Before the Board of Inquiry
Waterview Connection Project

Rebuttal evidence of **Robert Mason (Design Manager)** on behalf of the **NZ Transport Agency**

Dated: 2 February 2011

**ANNEXURE E – SH20 GREAT NORTH ROAD NORTHBOUND OFF
RAMP: SIR HAROLD'S OPTION**

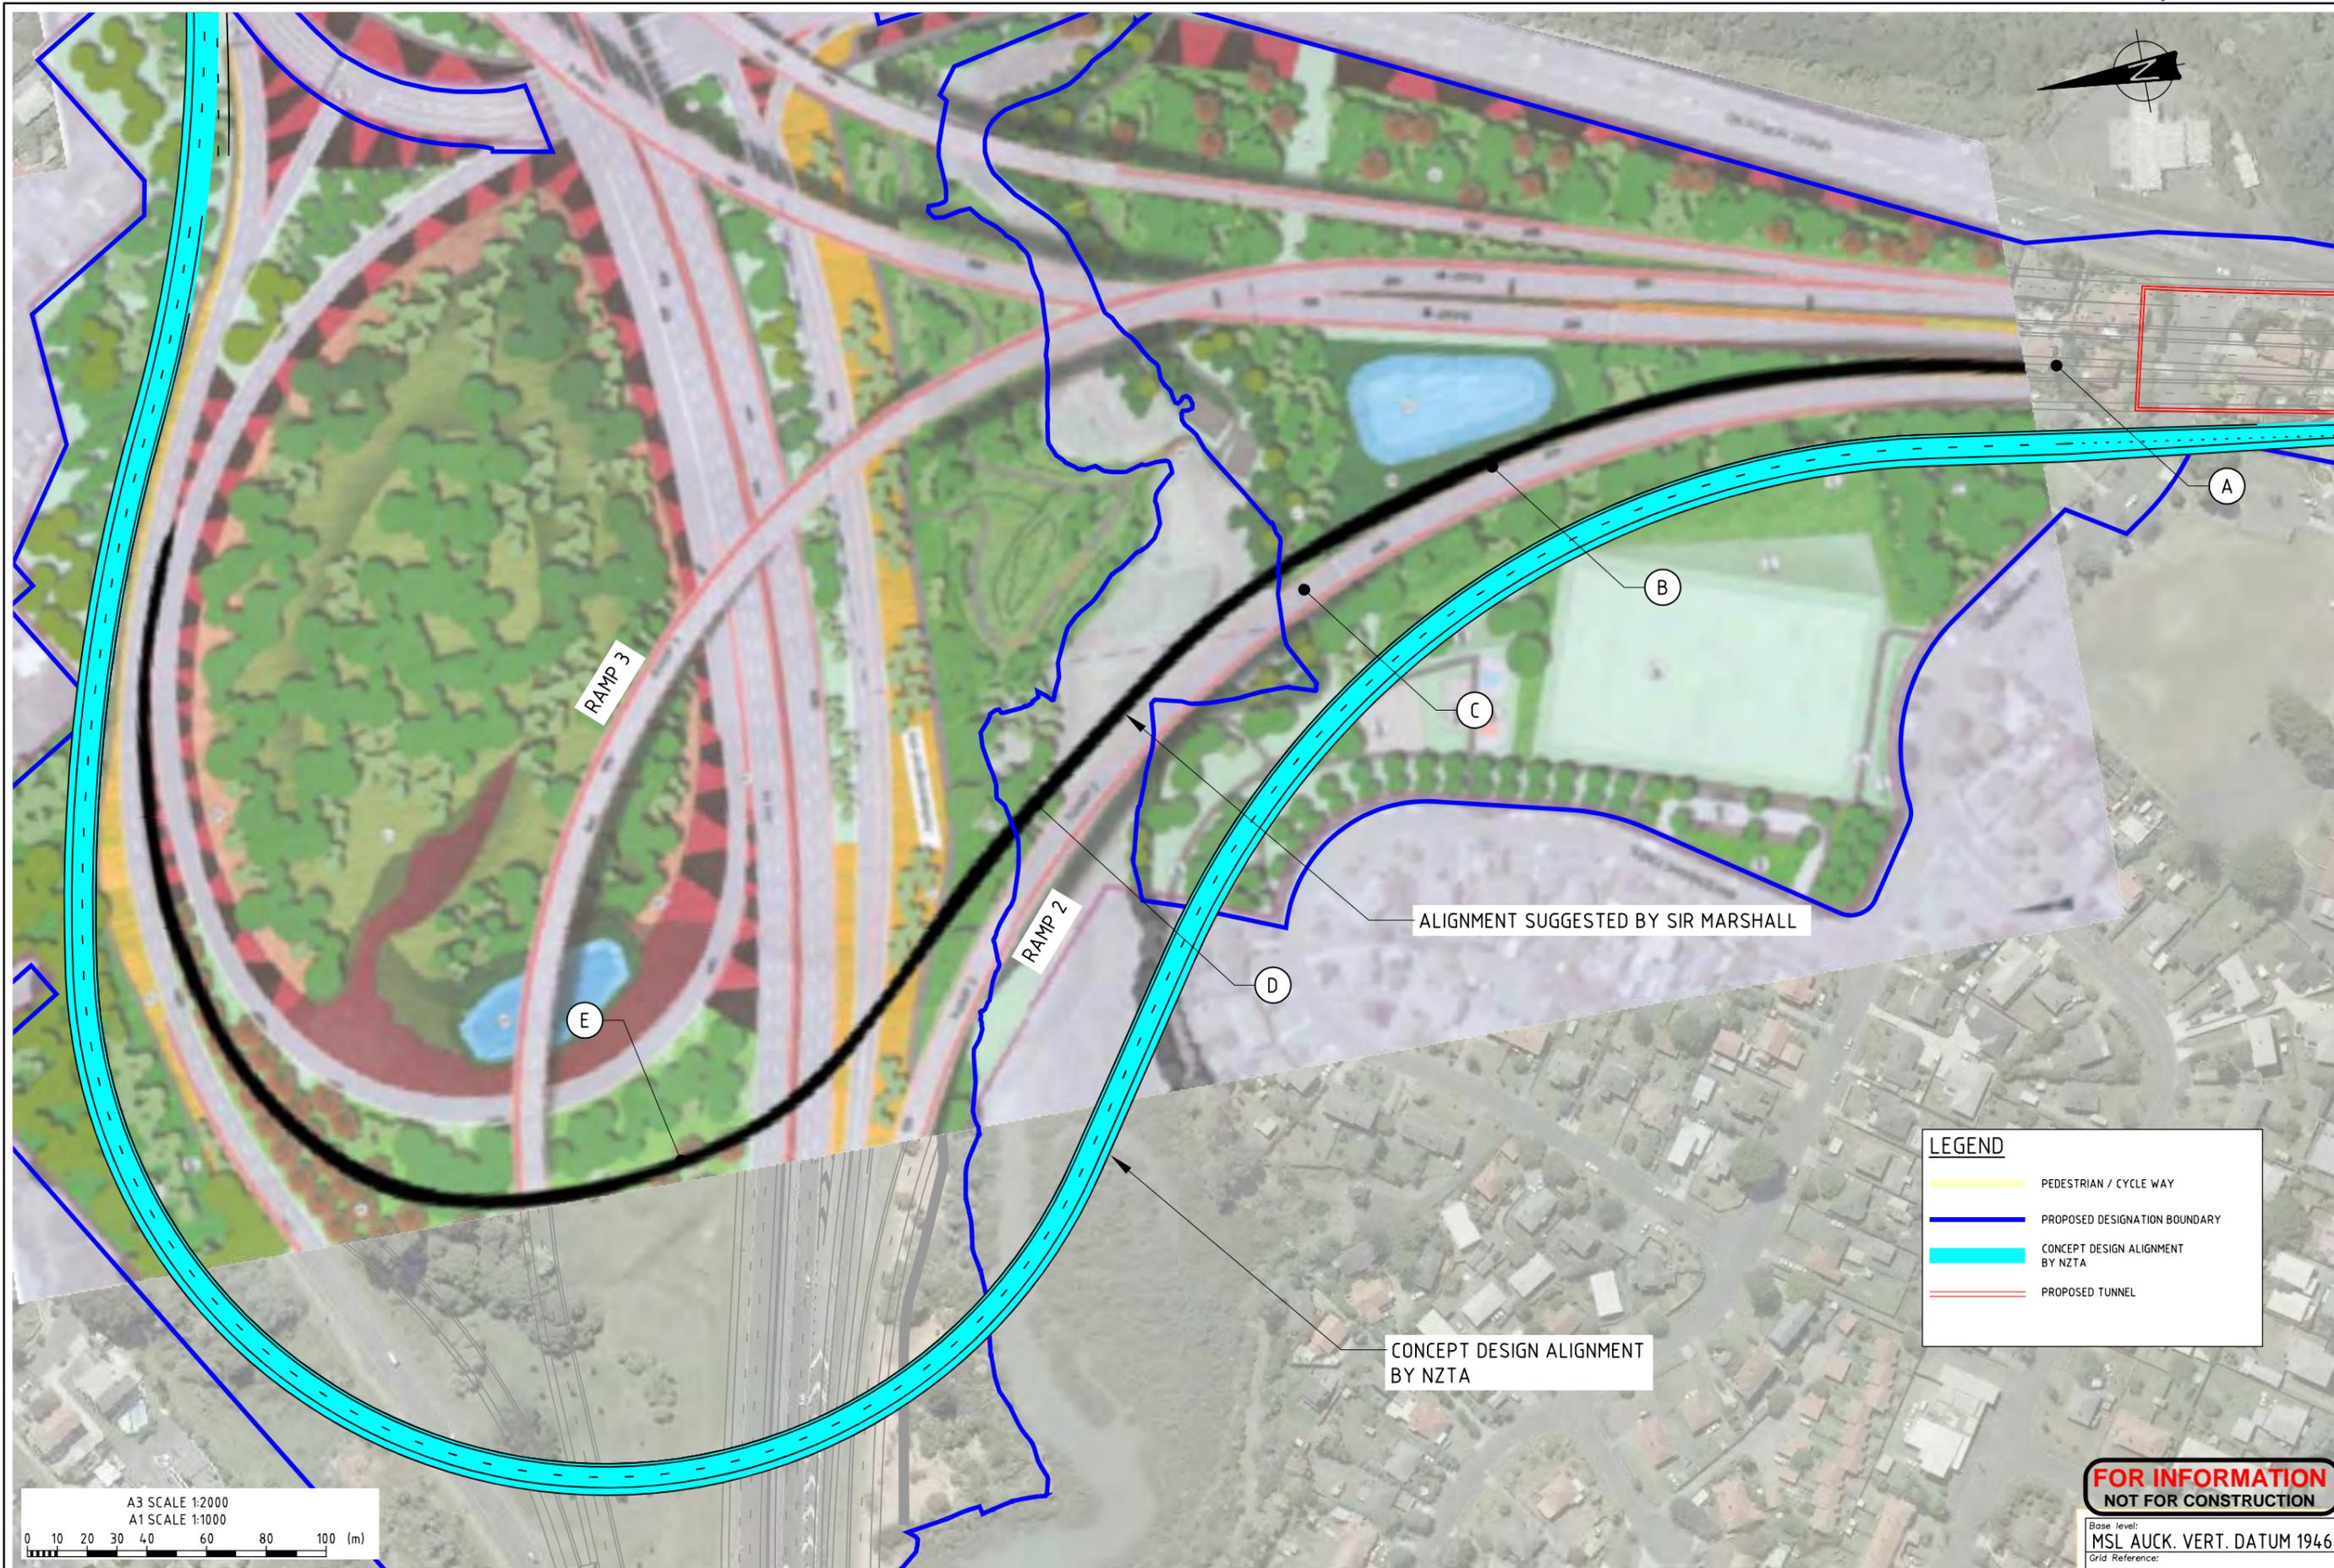
58.1 The suggested off ramp would diverge from the right hand side of the connection to SH16 west (Ramp 2 – as indicated by point 'B' on **Annexure E**), which provides for one of the key Western Ring Route connections, and consists of 2 westbound lanes. Sir Harold's proposed off ramp would need to diverge on the outside of a horizontal curve. This creates a safety hazard for a number of reasons:

- (a) At this location, the main alignment is on a tight horizontal curve and the greater radii of the diverging off ramp would be perceived by drivers as being the main route;
- (b) Due to the tight radii, the higher sight distance requirement for an off ramp would not be achievable, with the result being that drivers who have started to take the off ramp unintentionally would have little opportunity to correct. Any correcting manoeuvres on

- 58.3 The off ramp diverge would be positioned immediately after the diverge between the system ramps from the SH20 tunnel (being Ramps 2 and 4 – as **indicated by point 'A' on Annexure E**). The absolute minimum separation between ramp noses is 240m,⁴⁴ with a greater separation possibly required to provide sufficient weave capacity or to accommodate adequate signing. Therefore, Sir Harold's proposal would not provide sufficient separation between ramp diverges to allow traffic to identify the appropriate ramp diverge and safely move into the correct lane.

- 58.5 The vertical geometry of the **NZTA's** proposed Ramp 2 incorporates a crest vertical curve which provides a sight distance of 115m⁴⁶ (**indicated by point 'C' on Annexure E**). Therefore, a diverge exit from the outside of this curve would not be visible to approaching motorists, creating a significant safety issue. Considering this sight distance requirement and the need to provide sufficient spacing between ramp diverges, I consider that the ramp alignment suggested by Sir Harold presents a significant safety risk that would not be acceptable.

Title: **OPTION DEVELOPMENT**
SH20 CARRINGTON RD SBD OFF RAMP
SIR MARSHALL OPTION (120-1)

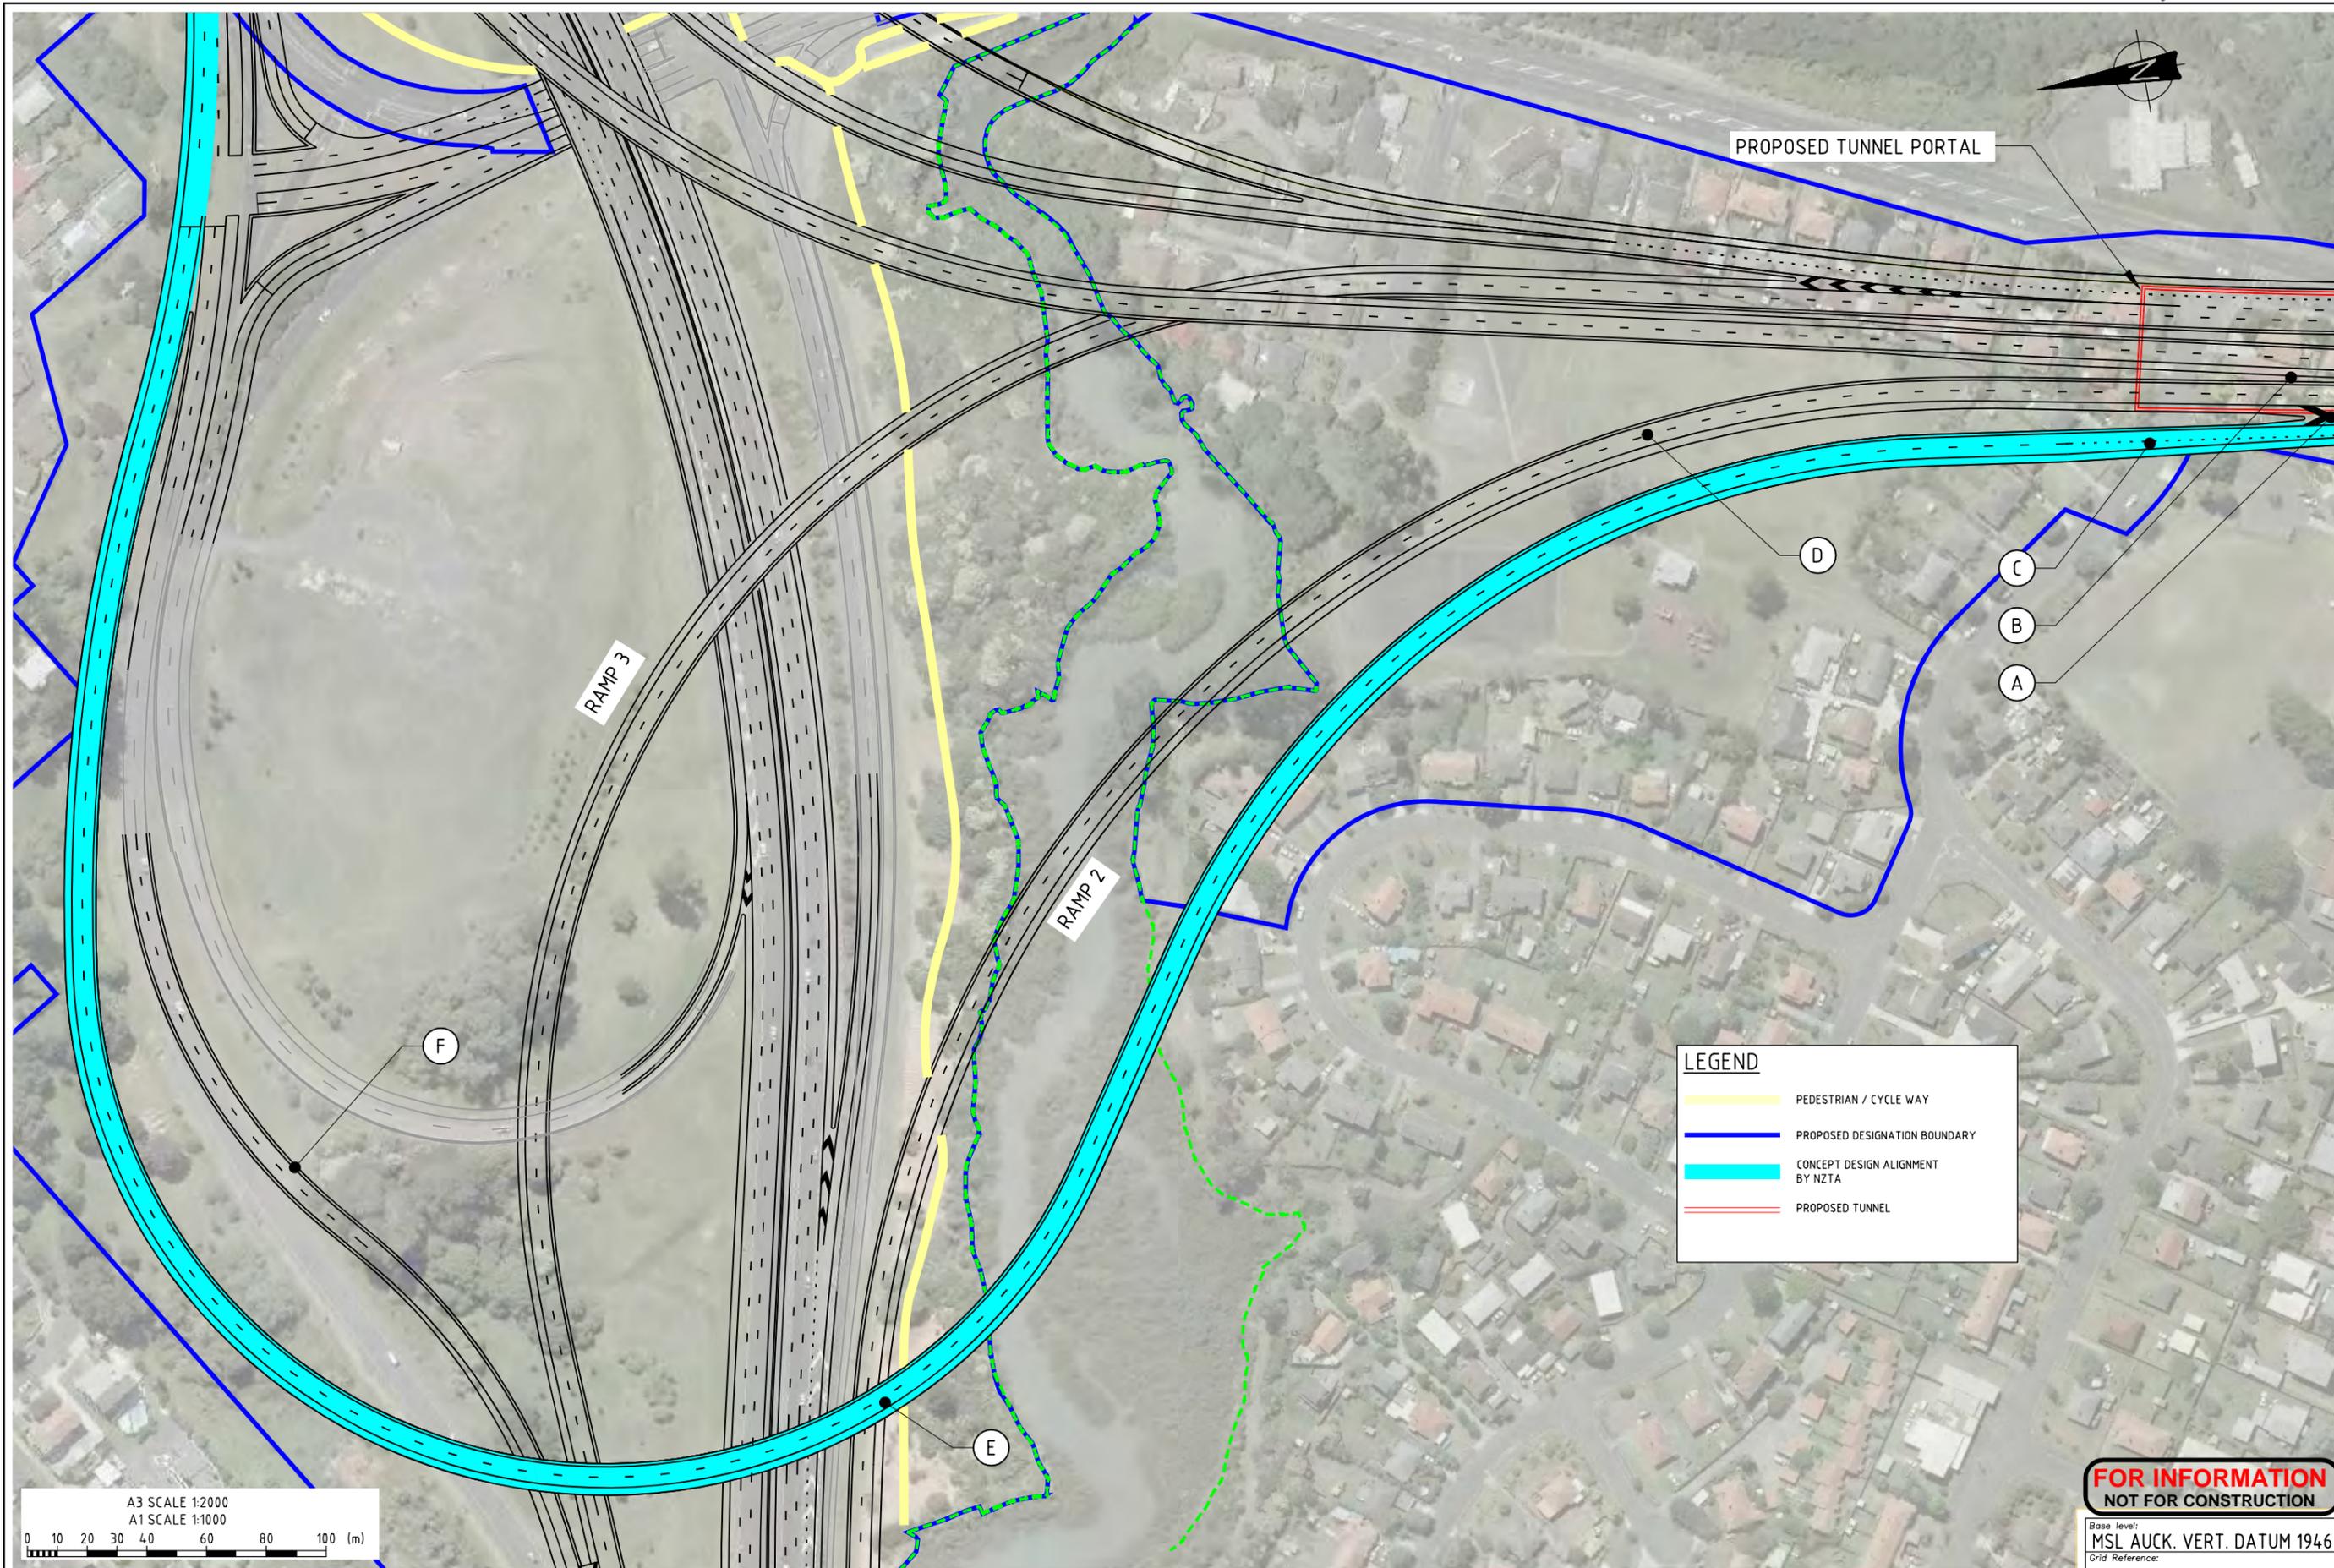
- 60.1 The diverge taper would begin a considerable distance into the northbound tunnel (**indicated by point 'A' on Annexure F**), requiring vehicles to change lanes within the tunnel. This is undesirable as it increases the risk of a weave accident within the tunnel.
